ATTACHMENT VI-2
STORMWATER MANAGEMENT

DRAFT

STORMWATER MANAGEMENT

FIGURE 2

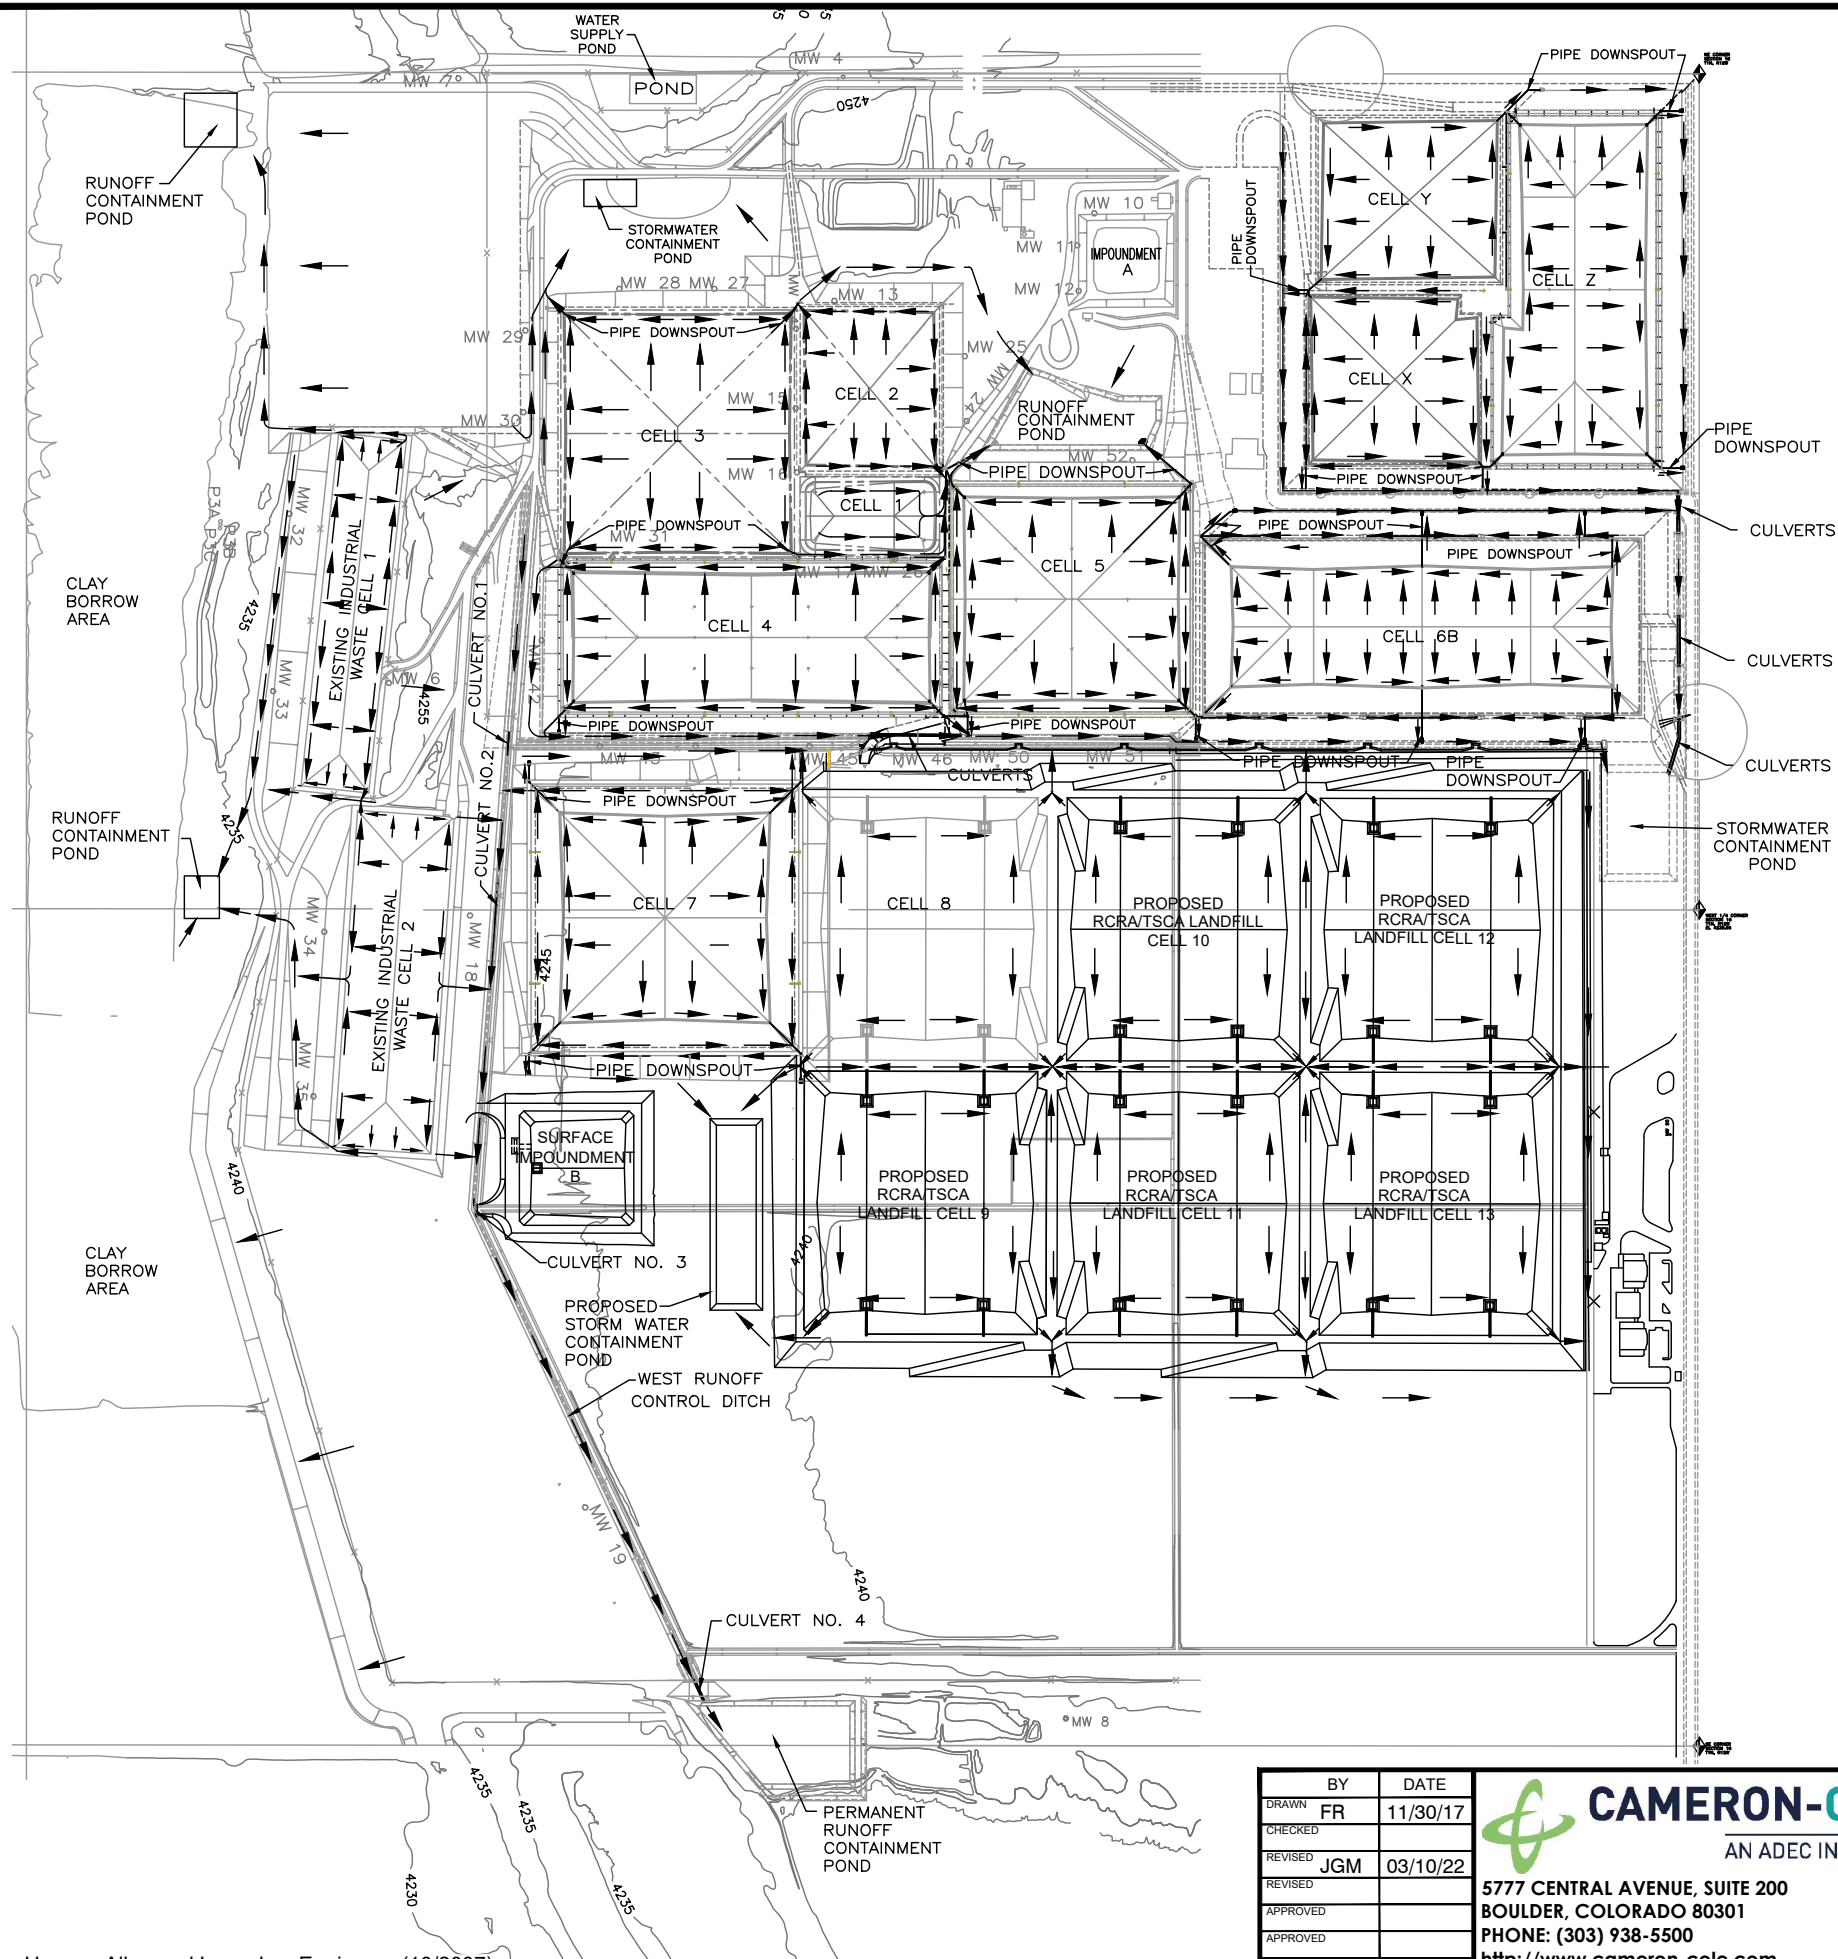
Figure 2: ~~Rainfall Frequency Distribution Curves~~ Stormwater Drainage Patterns after
Closure of All Landfill Cells

Figure 2 shows the design of the stormwater drainage patterns system, ~~that the runoff management system was designed to create in the area of Disposal Cells 8—13 and Surface Impoundment B.~~ The size of the stormwater containment ponds was based on the

~~assumed rainfall amounts and runoff generated from assumptions as to the amount of precipitation that run off the embankments and cell caps which that are tributary to the ponds and the volume of rain produced by a 100 year, 24 hour precipitation event.~~
